MILITARY SPECIFICATION

CIRCUIT CARD ASSEMBLY 11748240
(SIGHT CURRENT GENERATOR ADAPTER)

This amendment forms a part of Military Specification MIL-C-48585(MU) dated 17 November 1975.

Figure 1. Test Conditions

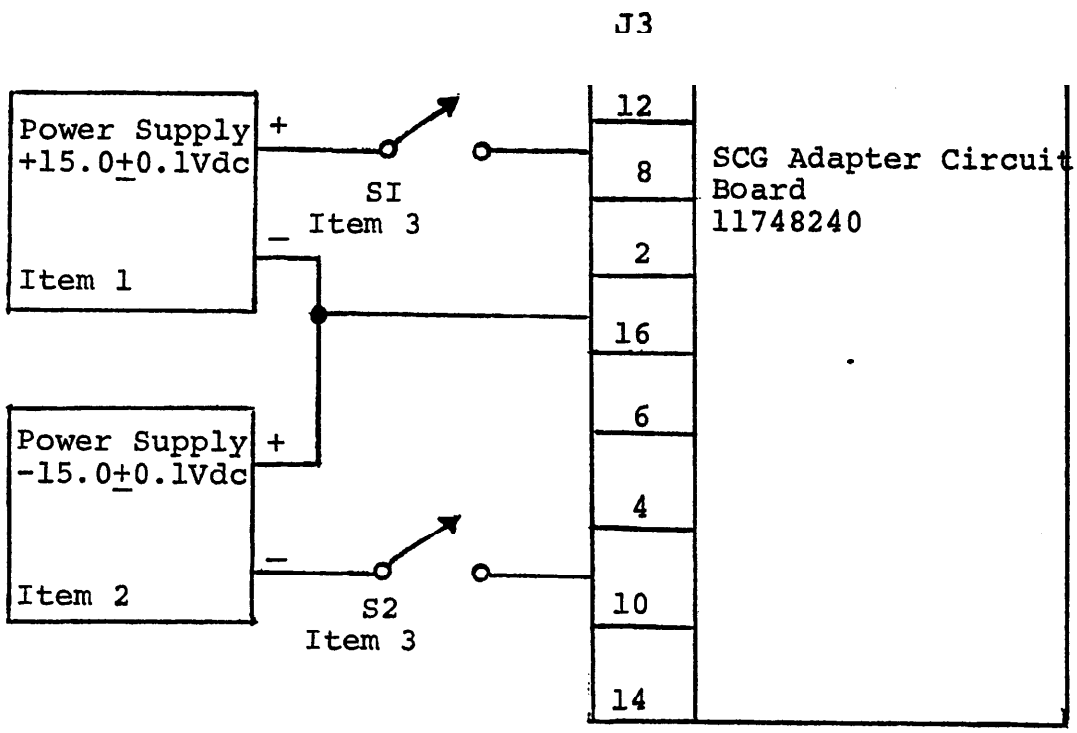
Figure 1: Delete and substitute below Figure 1:
